Subject: FW: Additional Mitigation - DELIBERATIVE - DO NOT DISCLOSE

Mitigation for Temporary Impacts

SeaTac 3rd Runway

Attachment A
Wetland A17 Complex

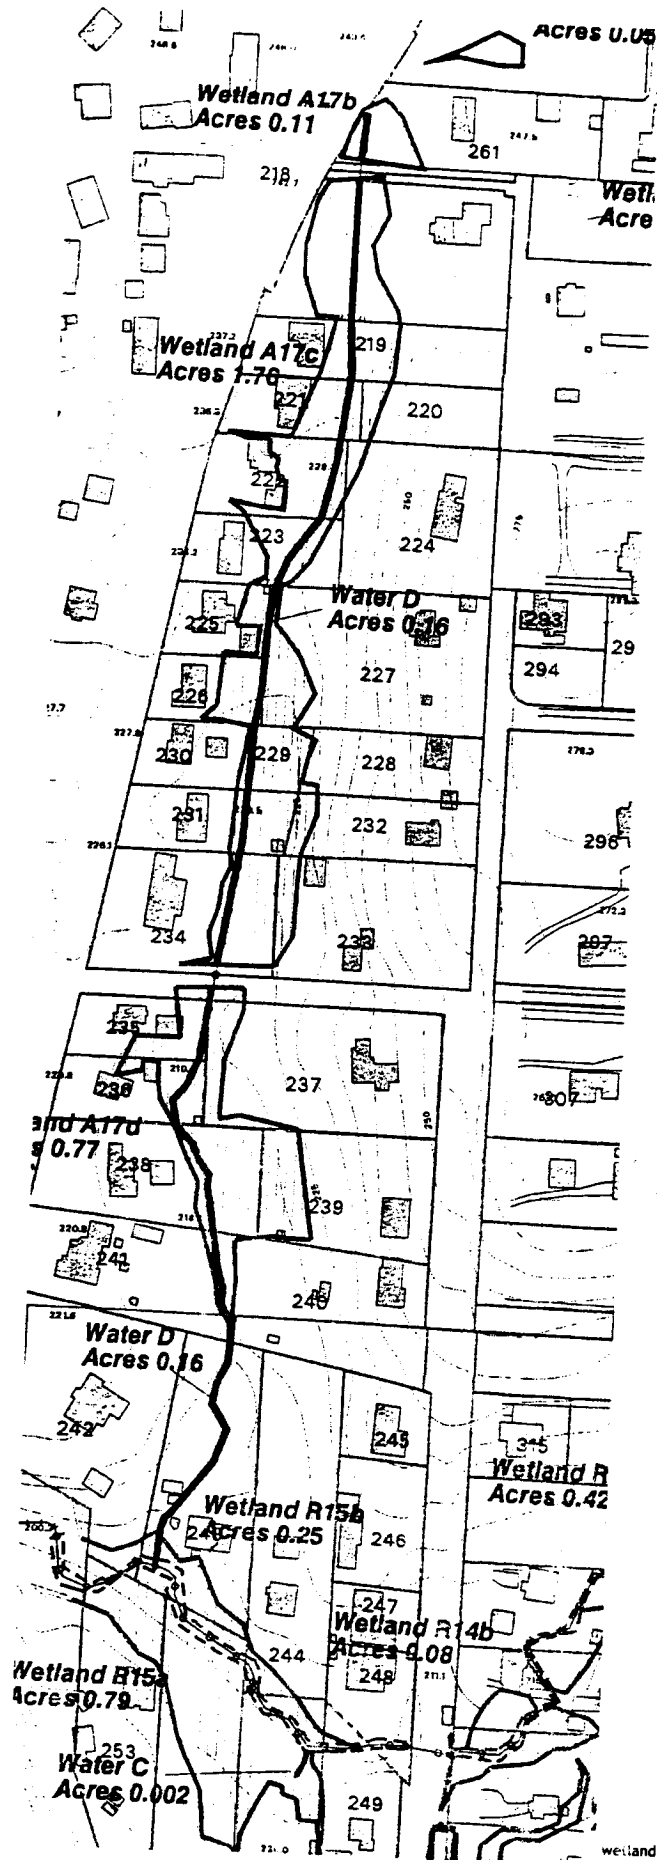
- The wetland/riparian zone comprised of wetland A17b/c/d and water D will be added to the wetland and buffer restoration/enhancement on Miller Creek. This area is depicted in Attachment A titled "Wetland A17 complex". A 100-foot buffer will be placed to envelop this system. The wetlands total 2.64 acres and "Water D" totals 0.16 acres for a combined total of 2.80 acres (not including the buffer). The buffer will be averaged, similar to the buffer on Miller Creek.

- The submittal will evaluate the feasibility of improving the hydrologic connection of wetland A17 complex to Miller Creek via "Water D".
- Homes, driveways, concrete, fill, septic systems and other unsuitable material will be removed from the wetland complex, similar to the treatment protocol for the Miller Creek restoration.

- The submittal will develop a buffer restoration and revegetation plan for this area, similar to the treatment protocol for Miller Creek. This will include the removal of invasive species, and replanting of appropriate native species.

- The submittal will evaluate the potential for wetland restoration and enhancement within this new mitigation zone.
- The buffer will be joined with the buffer on Miller Creek to the south.
